A/C TYPE EC155B
 A/C S/N 0583
 A/C REGN AM-SAS
 TYPE OF CHECK _____

DEFECT AND RECTIFICATION WORKSHEET/CERTIFICATE OF RELEASE TO SERVICE

ASB No. EC155-34A033

**Modification of the wiring of the FLIGHT/GROUND logic
(connector 11 ALPHA)**

Figure 1

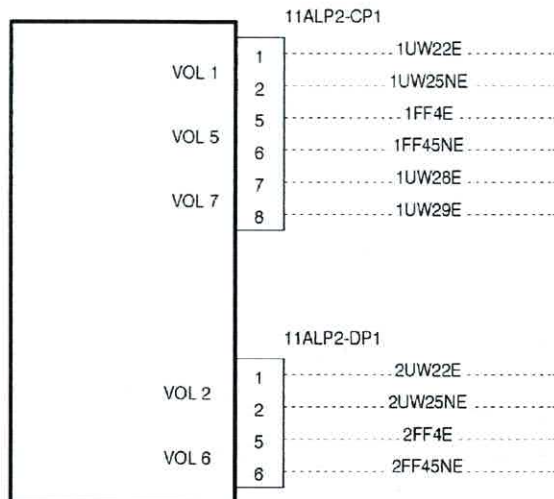
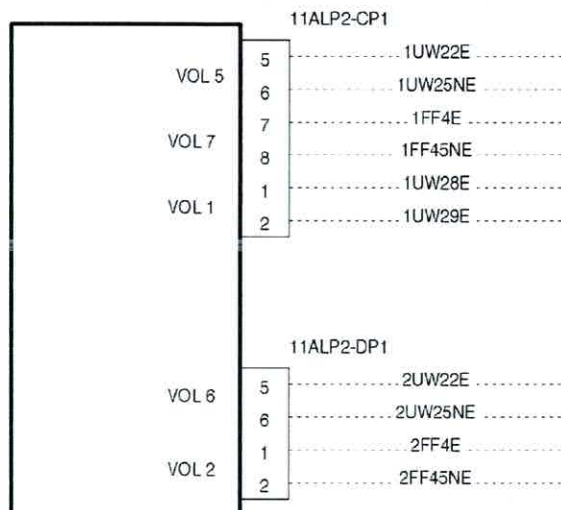
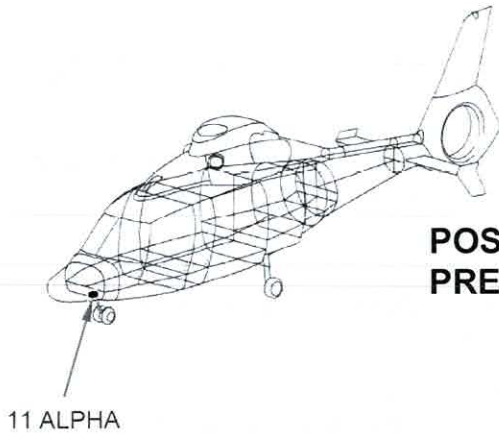
- 365A084754.00 which consists in re-allocating the electronic card outputs by modifying the connection to connector 11 ALPHA (helicopters PRE and POST MOD 0731B89),
- 365A084754.01 which consists in modifying the wiring of connector 11 ALPHA (helicopters POST MOD 0731B89).

- Perform the modification of the connection to connector 11 ALPHA as per [Figure 1](#).

Figure 2

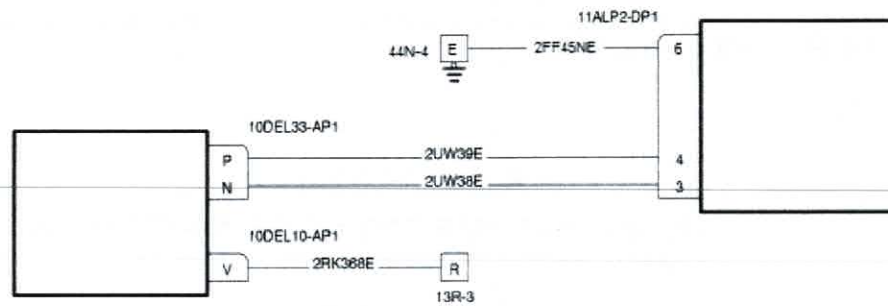
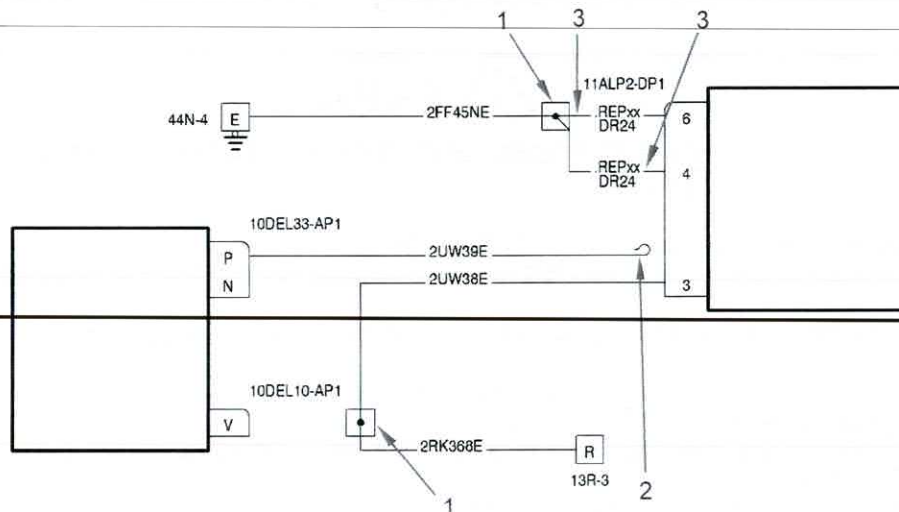
The components listed in the table above concern the modification of the wiring of connector 11ALPHA (modification 365A084754.01). These components are not necessary for helicopters PRE MOD 0731B89.

- Perform the modification of the connection to connector 11 ALPHA as per [Figure 1](#).
- Perform the modification of the wiring to connector 11 ALPHA as per [Figure 2](#).
